Hallam Land Management

Land North of Ancton

Arboricultural Technical Note

June 2022

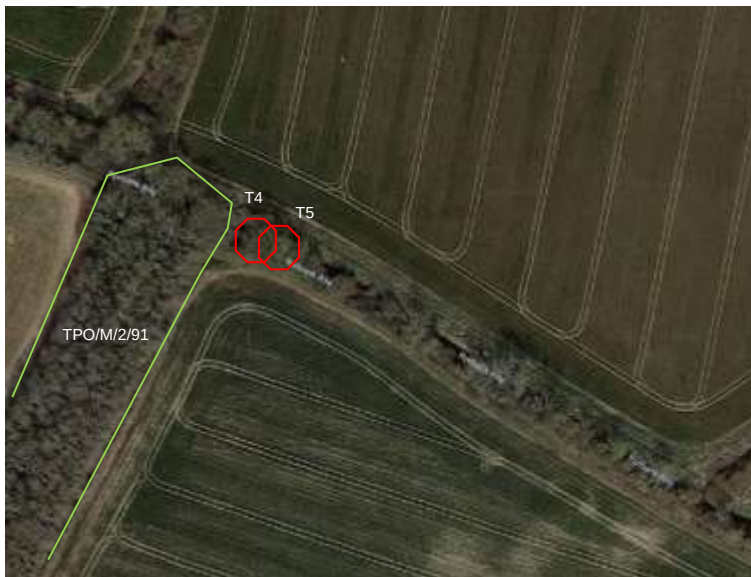
There is a potential area of conflict which I feel needs to be resolved around the terminus of hole 18; a substantial section (capturing part of tree groups G3 and G4) is to be removed. Within that section I suspect are two higher quality trees (retention category A/B) that I have identified for TPO (fig. 1).

The removal of tree cover, including the oak and maple in this location, is to allow for the unimpeded link between the 18th hole fairway and green which is situated to the north of the Ryebank Rife. Consultation has been held with the Golf Course design team to see if the retention of the two individual trees is possible with the removal of surrounding trees and vegetation. Unfortunately, the removal of the tree cover identified is unavoidable to provide the required course length and par. The relocation of the 18th hole would have wider implications for the masterplan, including a reconfiguration of the holes and siting of buildings on site. The layout has been informed by a thorough consideration of the constraints at the site and been through a number of iterations to ensure a suitable response to the existing landscape features, landscape setting, views into the site, safe access, etc. whilst meeting the requirements for the golf club in terms of the golf features that they require. Whilst two trees have been highlighted for potential retention the loss of these is not considered to be detrimental due to the extent of tree cover being retained

both across the site and also in the immediate vicinity of the trees to be removed. There will also be a net gain in additional trees planted at the site.
